UNITED STATES PATENT AND TRADEMARK OFFICE

APPLICATION NO.	FILING DATE	FIRST NAMED INVENTOR	ATTORNEY DOCKET NO.	CONFIRMATION NO.
10/000,147	10/19/2001	Alex Cho	49041-00018USPT	8492

**Office Action Summary**

### DETAILED ACTION

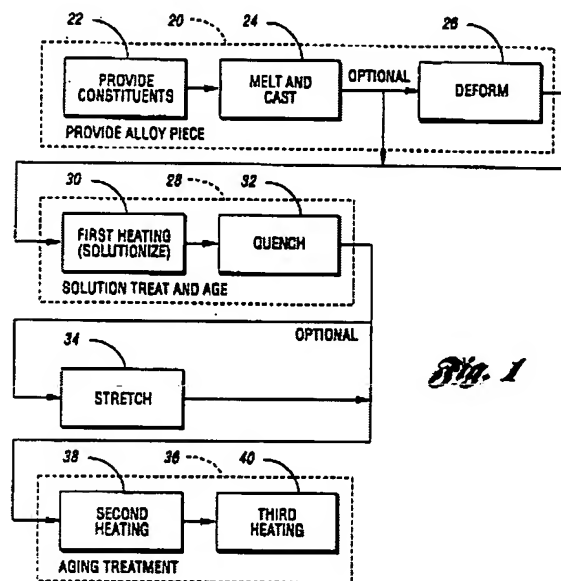
4. Claims 1-13 are rejected under 35 U.S.C. 102(a) as being anticipated by Waldron et al (US 6,074,498).

Waldron anticipates the claimed invention. Waldron teaches solution treating,

quenching, and heating in two steps an aluminum-copper alloy (see Figure 1 below).

The first heating step involves aging for 8-30 hr at 120-140° C [248-284° F], and the second heating step involves aging for 10-20 hr at 150-170° C [302-338° F] (Claim 1). Regarding Claim 2, Figure 1 shows a step of stretching. Regarding Claim 3, Waldron teaches producing a heat-treated aluminum-copper alloy (column 2, line 8). Regarding Claim 4, the alloy contains lithium (Claim 1). Regarding Claim 5, the alloy contains Zr, Fe, and Mg (column 3, lines 6-10). Regarding Claim 6, the alloy contains Mg, Li, and Si (lines 7-10). Regarding Claim 7, the alloy contains Zr and Fe (line 9). Regarding Claim 8, the alloy contains 2.6-3.3% Cu (line 7). Regarding Claim 9, the alloy contains 2.6-3.3% Cu and 2.0-2.4% Li. Regarding Claim 10, the alloy contains Li, Mg, and Zr (lines 7-10). Regarding Claim 11, the solution treatment is 425-600° C [797-1112° F] (lines 37 and 38). Regarding Claim 12, the first aging is for 8-30 hr. Regarding Claim 13, the second temperature is 10-30° C [18-90° F] greater than the first

Waldron anticipates the claimed invention. Waldron teaches solution treating, quenching, and heating in two steps in Figure 1 an aluminum-copper alloy. The first heating step involves aging for 8-30 hr at 120-140° C [248-284° F], and the second heating step involves aging for 10-20 hr at 150-170° C [302-338° F] (Claim 1). Regarding Claim 16, Waldron teaches producing a heat-treated aluminum-copper alloy (column 2, line 8). Regarding Claim 17, the alloy contains lithium (Claim 1). Regarding Claim 18, the alloy comprises 2.6-3.3% Cu. Regarding Claim 19, the alloy contains 2.6-3.3% Cu and 2.0-2.4% Li. Regarding Claim 10, the alloy contains Li, Mg, and Zr (lines 7-10). Regarding Claim 20, the second temperature is 10-30° C [18-90° F] greater than the first temperature.
